TECHNICAL EVALUATION REPORT

HYDROLOGICAL CONSIDERATIONS

CONNECTICUT YANKEE ATOMIC POWER COMPANY
HADDAM NECK PLANT

NRC DOCKET NO. 50-213

Figure 7. Flood Protection Location Plan

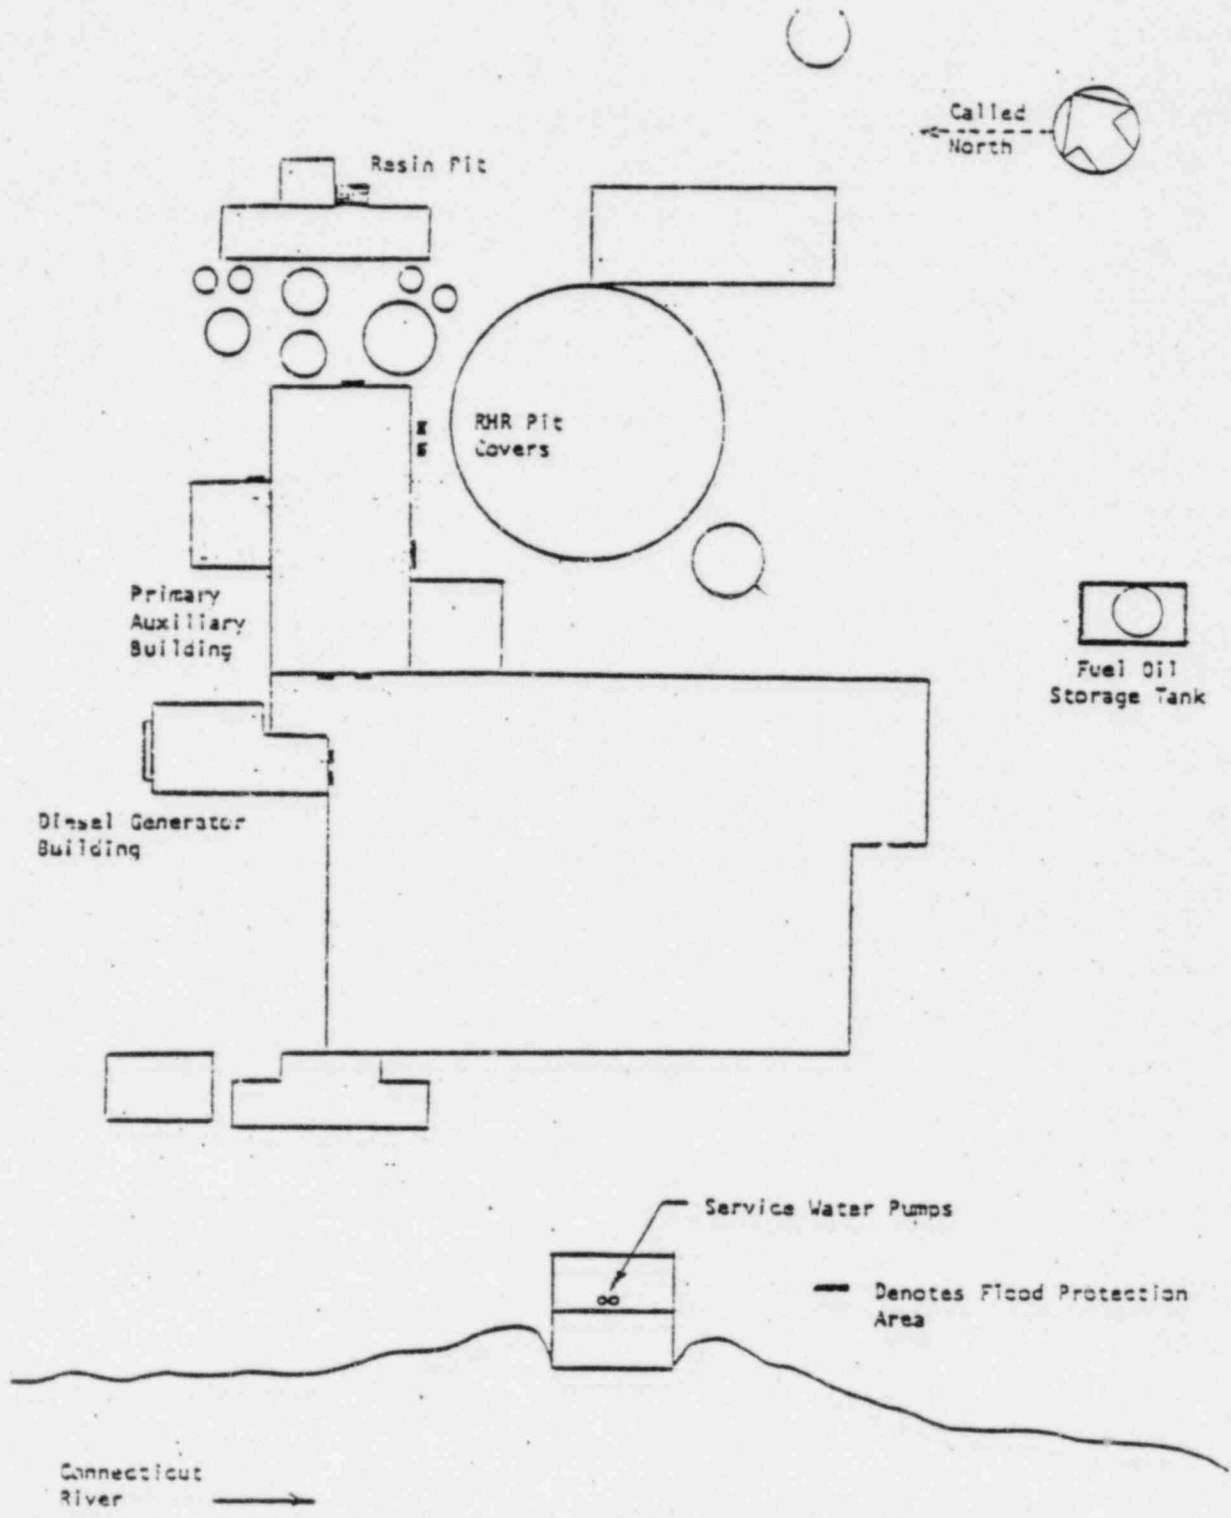
The Licensee proposes to build a structure to contain stoplogs as a barrier to flood waters at the entrance to the emergency diesel generator building. On May 10, 1982, the exact configuration of this device had not been decided [23]. Assuming this structure can withstand the dynamic and static loading of water, and providing that suitable access ladders are in place, this type of barrier may provide suitable protection for the diesel building for floods as high as 40 ft msl.

The proposed fiberglass service water pump motor sleeves, which are to provide protection against floods above grade (21.5 ft msl), can be considered hardened protection if they can be put in place with little effort and in a short amount of time (i.e., approximately one hour). Further concern exists with respect to the protection afforded these service water pump motors against large floating debris transported down the Connecticut River. When river levels reach above 25 ft, the screenwell house will be nearly submerged and susceptible to collision of floating debris. Louvered windows are immediately adjacent to the service water pump motors. Further, no consideration has been shown to the effects of rising air temperature within the confines of the fiberglass sleeve on successful operation of the service water pump motors.

The Licensee's proposal to caulk around all concrete plugs of the trench entering the PAB may be insufficient. The head of water over these trenches

may be sufficient to force water through the trench and into the PAB. Further protection is warranted.
